REPORT OF GEOTECHNICAL INSPECTOR

Name of Property: Myra Falls Permit No.: M-26

Company: Nystar Myra Falls Ltd.

Date of Inspection: January 18, 2018

Photo 2: Price Portal Loadout

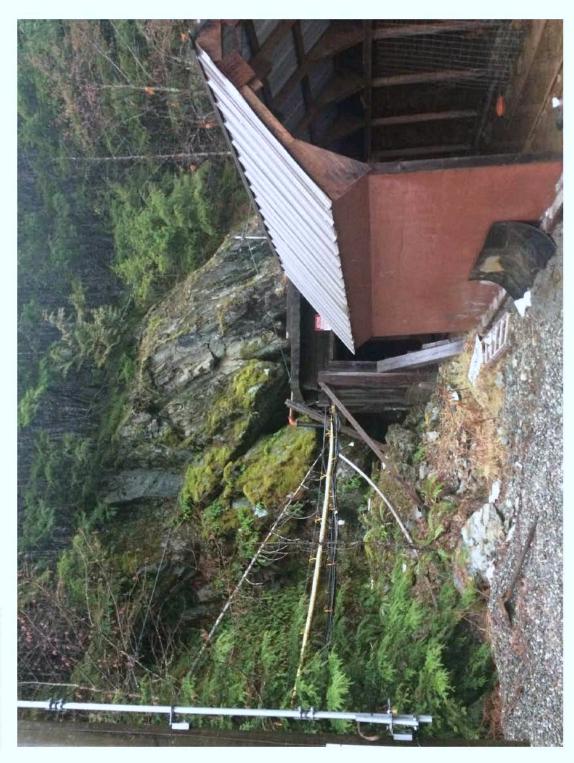
The Price Mine 13 Loadout Area (Photo 2) is located off the Jim Mitchell road, previously allowing railcars from the Price 13 portal to dump to a loadout area. The Nyrstar identified Polishing Pond 2 is located downstream of the loadout area. The proposed upgrades to this area include provision of a turn-around area for trucks, realignment/grading of the roadway, culvert upgrades, and provision of separation between the loadout area and the public road.

Photo 10: Lynx TDF Upslope Waste Rock Dumps

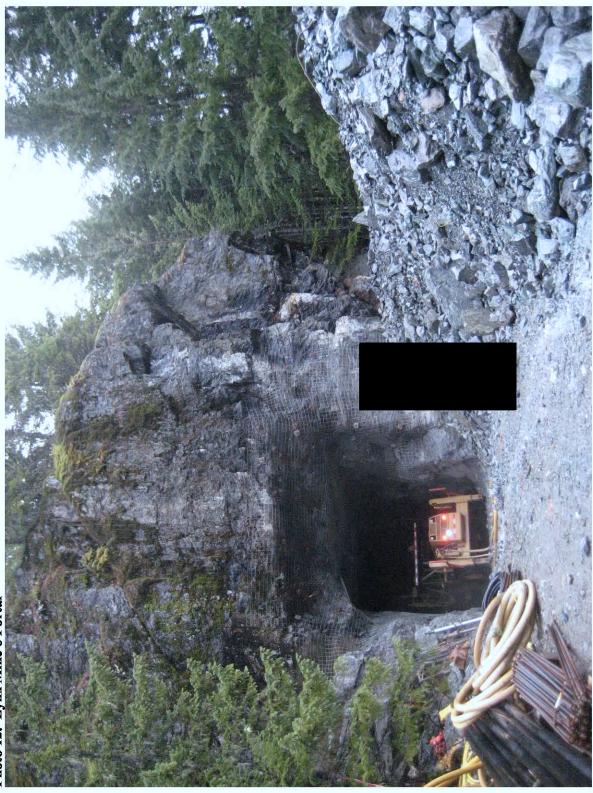
At the time of the site visit, the EoR (Amec Foster Wheeler) was on site performing an inspection of the facility. A raise was recently completed on the Lynx TDF dam. Amec Foster Wheeler (Dan Hughes-Games) noted that the upper portion of the upstream zone was completed with till, as other material was not available. Adequate freeboard was noted in the Pond (Photo 9). Surface flows from the upslope waste rock dumps were reporting to the TDF pond (Photo 10).
